From: Vamsi Sridharan - NOAA Affiliate <vamsi.sridharan@noaa.gov>
Sent: Friday, May 24, 2019 12:47 PM
To: Micko, Steve/SAC
Cc: Perry, Russell; Cathy Marcinkevage - NOAA Federal; Adam Pope; J Stuart; Leaf, Rob/SAC; Sumer, Derya
Subject: Re: [EXTERNAL] Re: Preliminary ROC on LTO plots to start discussion

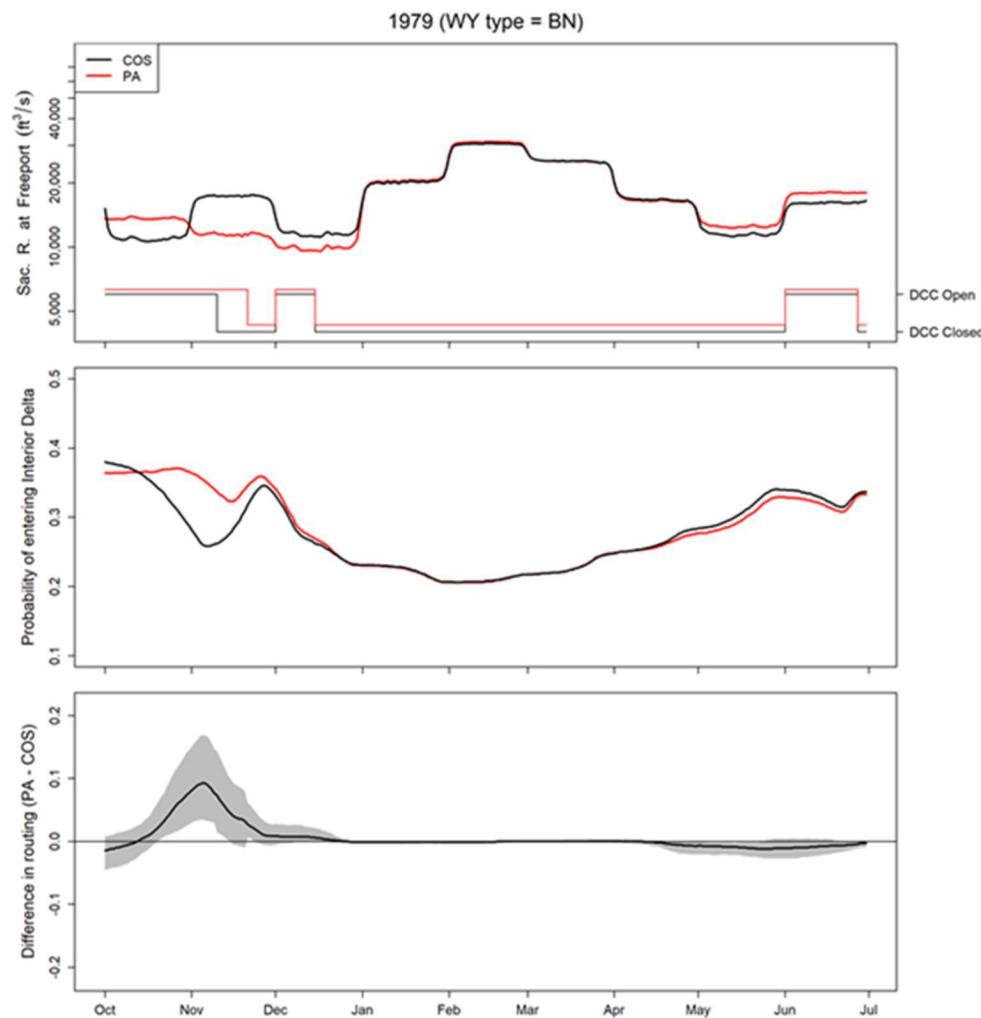
Thanks for the help in understanding how daily flows were constructed from the monthly flows. I have another question about DCC operations to help us interpret our results. In October/November we are finding some differences in DCC operation between scenarios in some years (see top panel below). Can you tell us the control rule that is causing there to be different DCC operations between scenarios? It doesn't appear to be flows > 25 kcfs, which triggers a DCC closure.

CalSim II develops the DCC operation schedule. Although there is a proposed change to DCC operations, model representation of the proposed DCC operations are the same in COS and PA. Proposed changes cannot be captured within the CalSim model.

I believe the CalSim II implementation of October 1 – December 14 period in NMFS BO Action 4.1.2 causes different DCC operations between COS and PA. In the PA, CalSim II opens DCC gates for more days in October/November (depending on the year) to meet water quality standards at Jersey Point and Rock Slough.
